**RE: 339-341 Bella Vista Avenue**

## ARBORIST REPORT

**341 Bella Vista Avenue  
Los Gatos, California**

**Re: 341 Bella Vista Avenue, Review of 9/5/14 Revised Plans relative to Existing Tree Protection**

Section through Bella Vista Avenue looking north

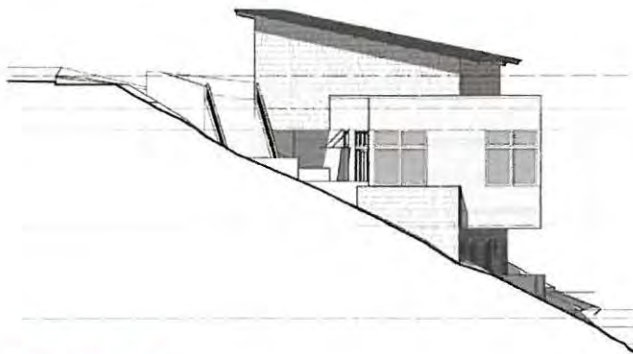
I have only one minor concern. The upper living level roofs will be visible from Bella Vista Avenue (see section diagram below). I saw many people walking along the west edge of the pavement during my site visit since there are no sidewalks in this area. The roof on the southern portion of the house is proposed to be covered with stone paving, the roof over the northern portion is proposed to have a gravel roof. The plans and other drawings show planters at the edge intended to contain landscaping to shield views to the roof. However, it is generally unwise to rely on future owners to provide or maintain adequate landscape buffers as the sole mitigation measure. My recommendation would be to provide more visually suitable paving on this portion of the roof.

## TREE MAP

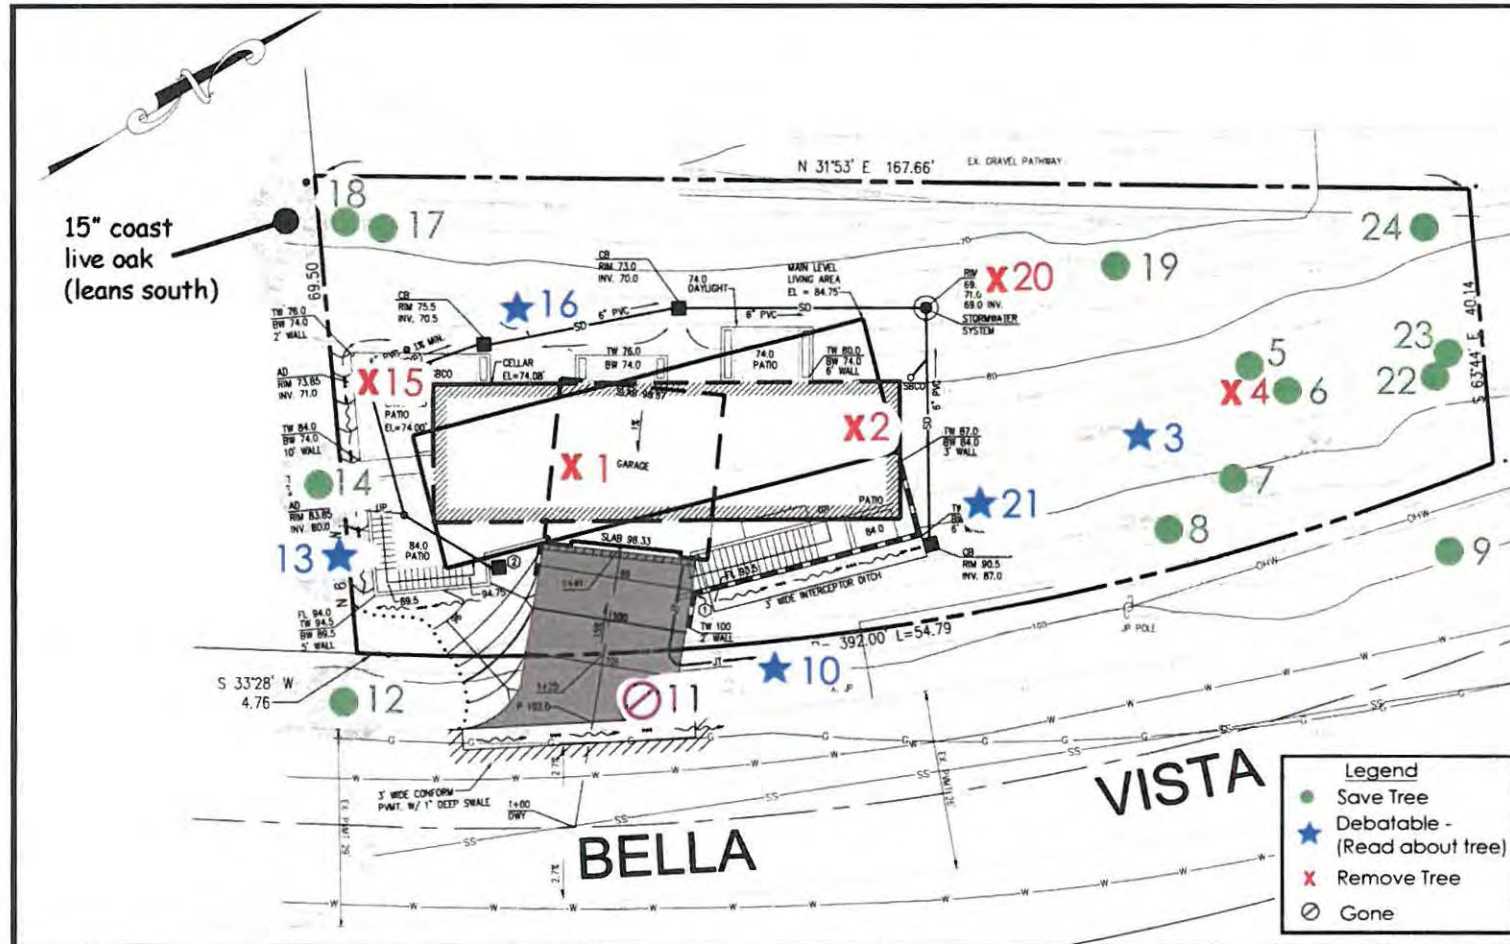
1. **Remove the following 5 trees: #1, 2, 4, 15 and 20.**
2. **Save and protect the following 13 trees: #5, 6, 7, 8, 9, 12, 14, 17, 18, 19, 22, 23 and 24.**

3. **The following 5 trees are listed as "Debatable".** Read about these trees in the Notes column of the Complete Tree Table in order to determine how to deal with them. Design changes are recommended for some of these trees: **#3, 10, 13, 16 and 21.**

Tree Map (see Notes, page \_).

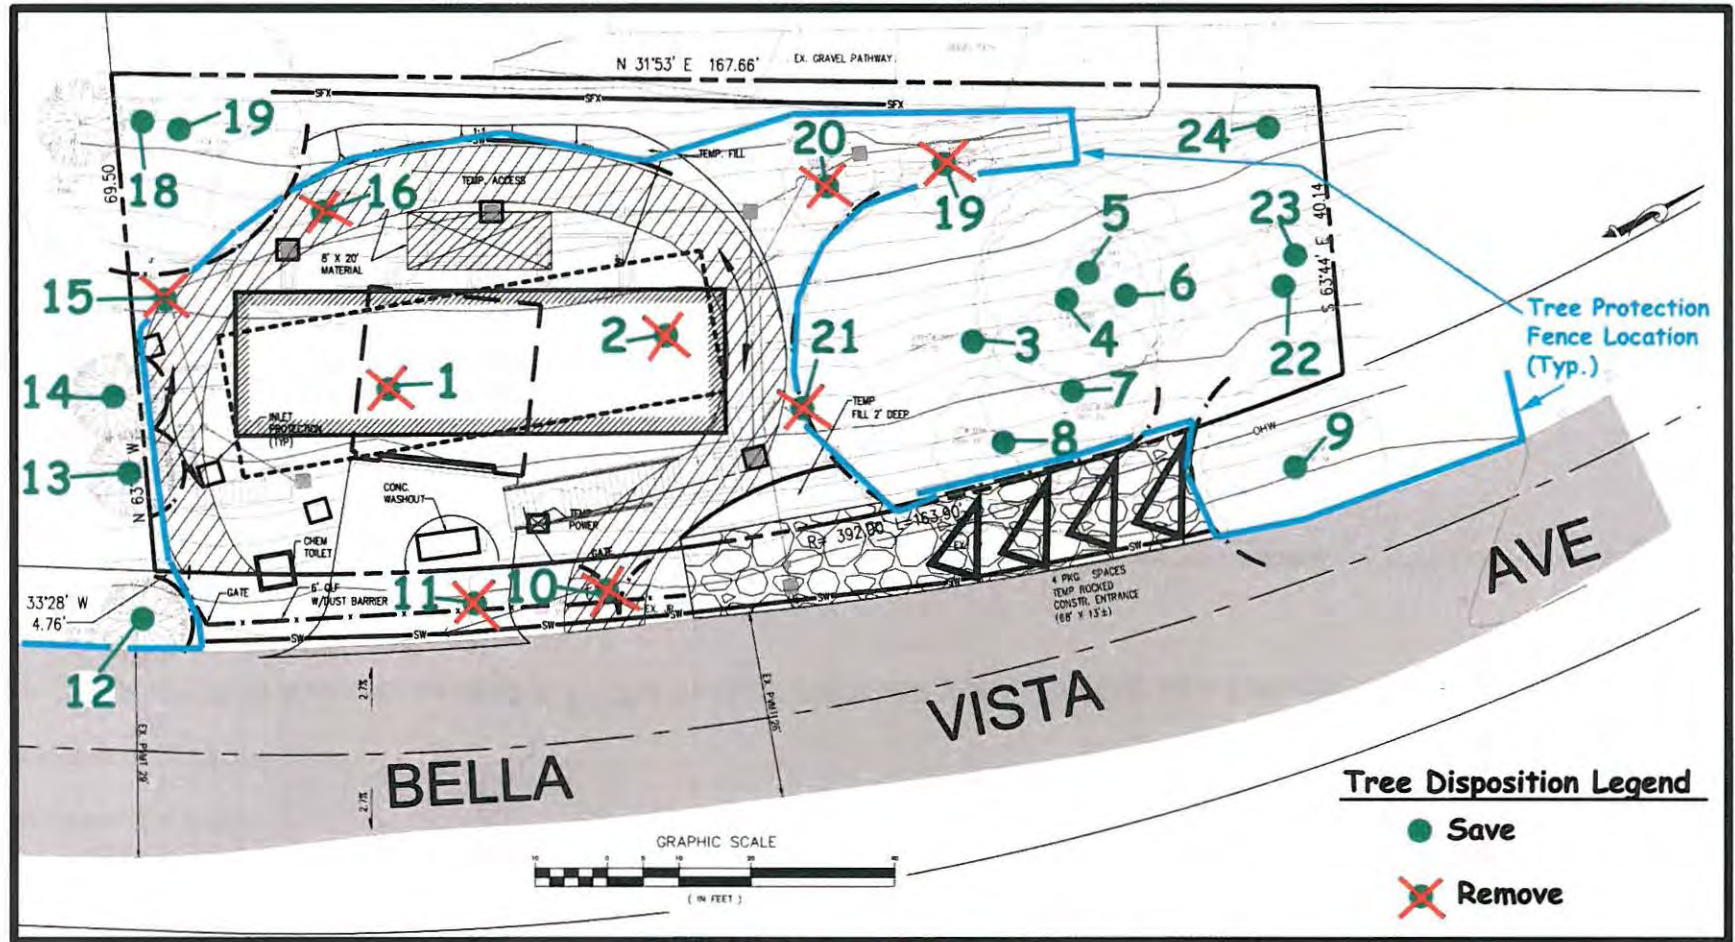
1. The plan sheet used for the Tree Map is the *Site Logistics & Construction Management Plan*, sheet C-3. All of the proposed improvements shown on the 9/5/14 C-Sheets (C1-4) are not shown on this plan, so it may not be obvious why a particular tree is shown to be removed. Read the "Action" and "Notes" column in the Tree Table to find out why a particular tree is listed to be removed.
2. The *Trunk Diameter*, *Size* and *Condition* ratings in the Tree Table are from my last evaluation of the trees and the site on October 24, 2013. I did however, ride by the site last week to take a brief look around. The site and the condition of the trees do not seem to have changed appreciably since my October 2013 evaluation.

There are few more trees that will need to be removed than are indicated on the C-3 plans. The reason for this is that not all improvements have been shown on all plans, and a few necessary tree removals were missed because of this. The current tree removal list in this report is a compilation of all improvements on all of the C-3 sheets. Most of the trees that will be removed except for **trees #1, 2 and 10** have been rated as having "Fair" or less preservation suitability, so the majority of trees that will be removed are not good specimens.

4. **Note the revised location for tree protection fencing** on the Tree Map in this report.

1. **Remove the following 10 trees: #1, 2, 4, 10, 11, 15, 16, 19, 20 and 21.**
2. **Save and protect the following 14 trees: #3, 5, 6, 7, 8, 9, 12, 13, 14, 17, 18, 22, 23 and 24.**
